To <david.jones@dps.la.gov>
 cc <dammoneng@bellsouth.net>
 bcc
 Subject Tabernacle Baptist Church - PO376923

March 16, 2010

Dammon Engineering, Inc. A1-Floor Plan.pdf

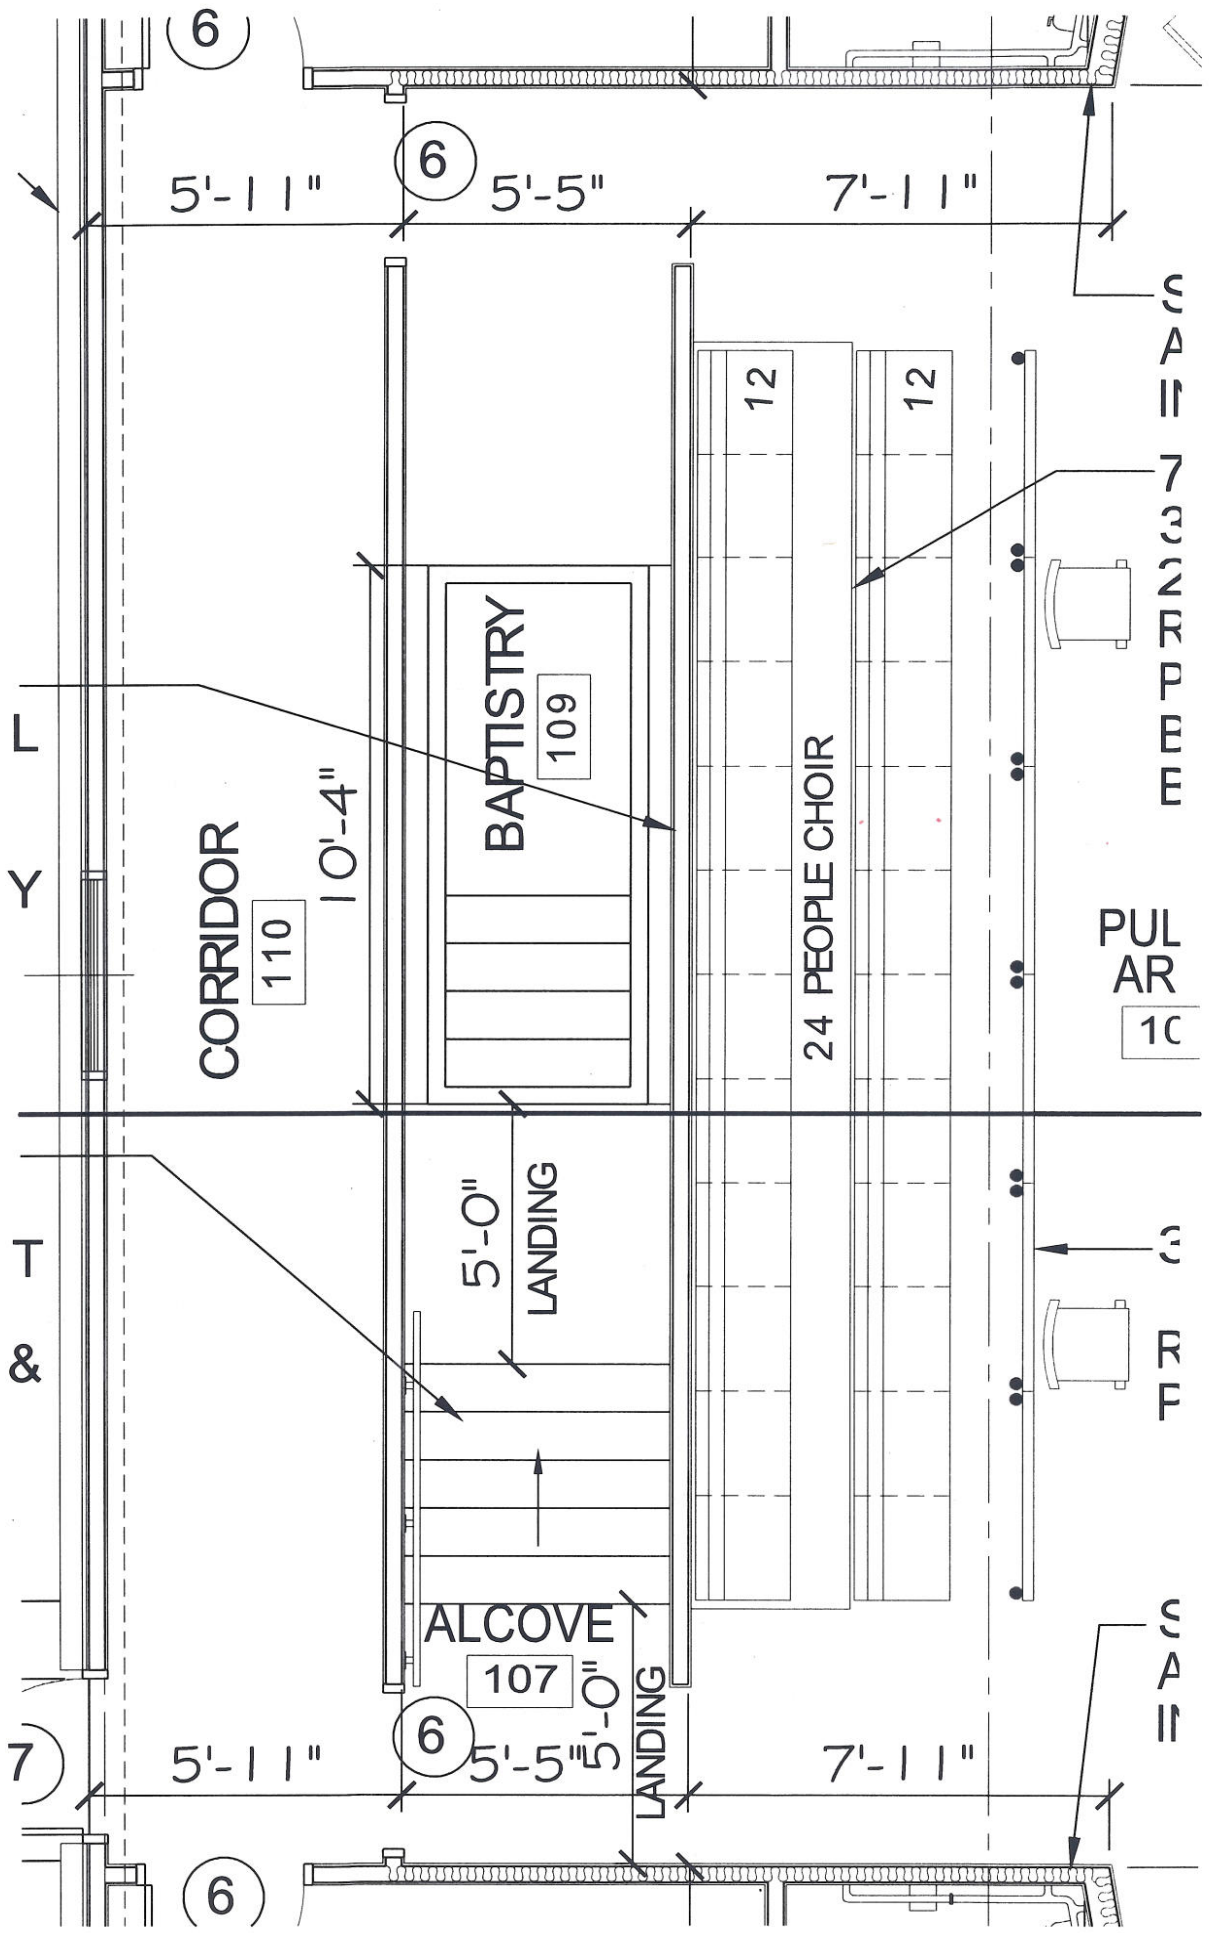
Thanks for the heads up on this project. Attached, please find a revised layout of the baptismal with access from one side only, that frees up enough space to have proper landings at top and bottom of the stair leading to the baptismal. Let me know if any further adjustments are necessary.
